March 19, 2019

Project No. 12091-01

**Subject: Preliminary Geotechnical Evaluation and Response to City Review Comments for Proposed San Pedro Distribution Center, 1599 W. John S. Gibson Boulevard, Los Angeles, California**

PROJECT NAME	San Pedro Distribution Center
PROJECT NO.	12091-01
ENG. / GEOL.	BTZ / KBC
SCALE	1" = 40'
DATE	March 2019

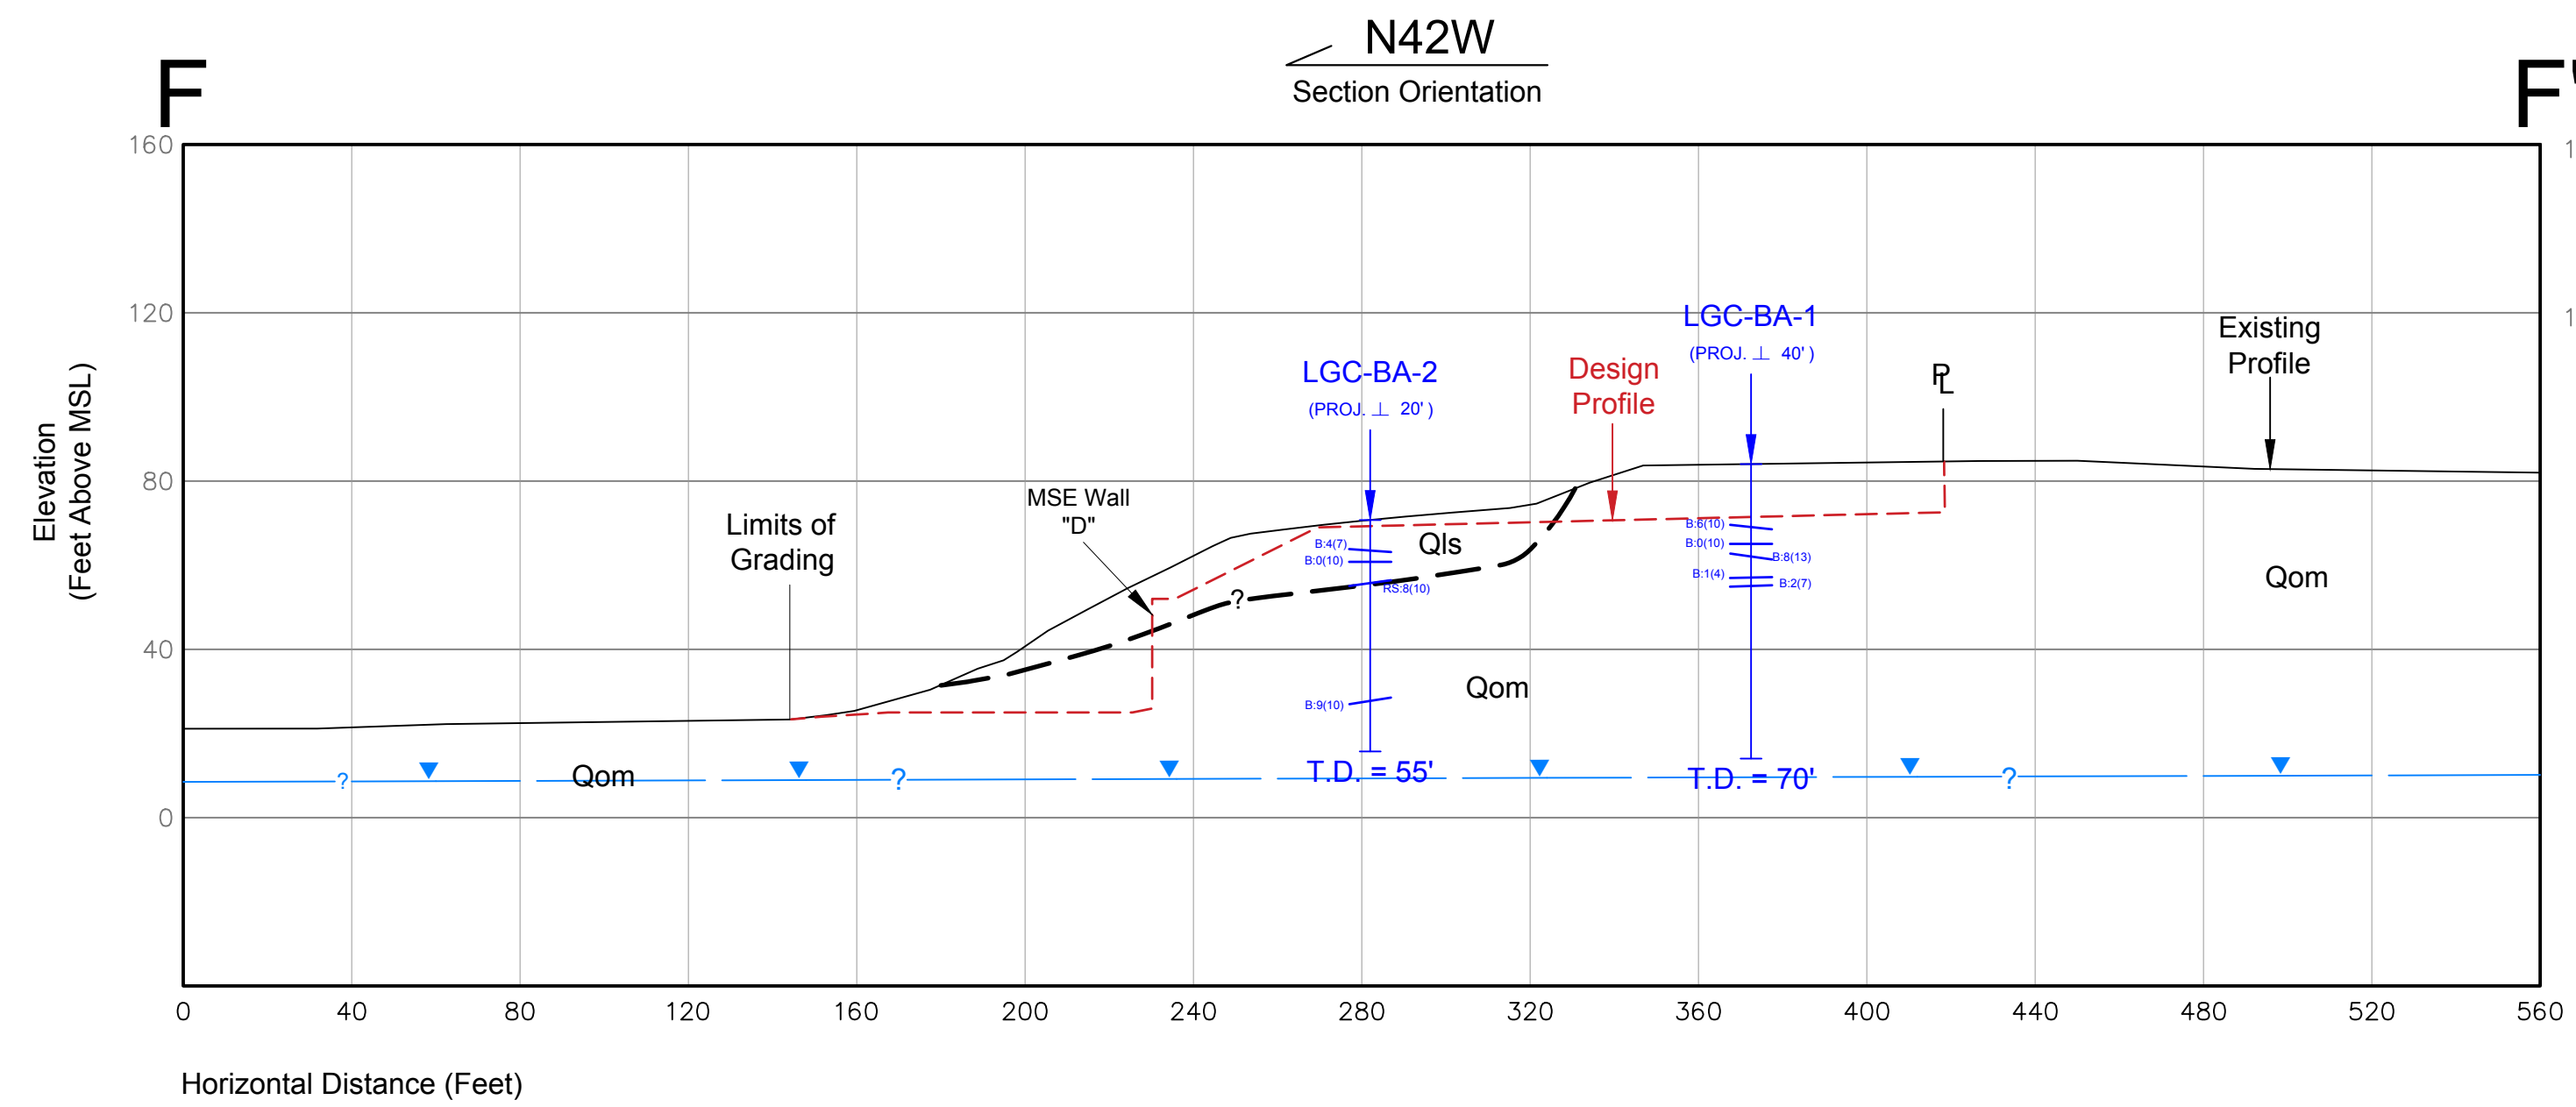
“Provide a geologic map and cross sections that are based upon conceptual grading or site development plans, to illustrate all proposed and existing contours relative to the planned grading and/or construction, along with all off-site slopes and conditions that could adversely affect the stability or safety of the site (7006.3.2). The geologic map and cross sections shall depict the top and bottom of slopes; lithologic contacts; bedding attitudes; locations of slumps, landslides, or faults relative to the subject site; existing and proposed topographic profiles; existing and proposed structures; and, required Code setbacks. (7006.3.2)”

“Provide geological cross sections illustrating existing and proposed grades and structures through the highest, steepest and geologically critical slopes.”

Refer to the attached Geotechnical Map and Geotechnical Cross Sections (Sheets 1 through 5). No building structures are planned for the site.
